SITE PLANNING

15.96.100 – Building location and orientation.

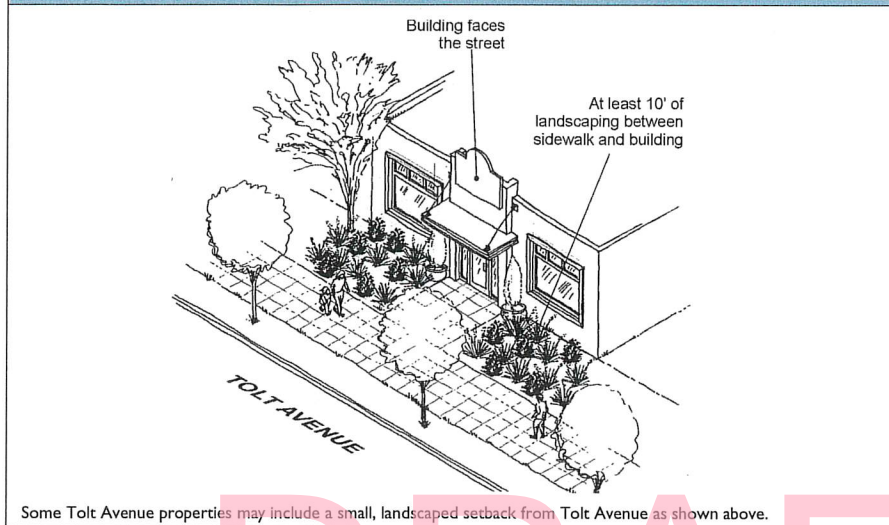
Commented [BB5]: Making sure the standards are in the text and not just the graphic!

Commented [BB6]: Updated graphic with updated percentages
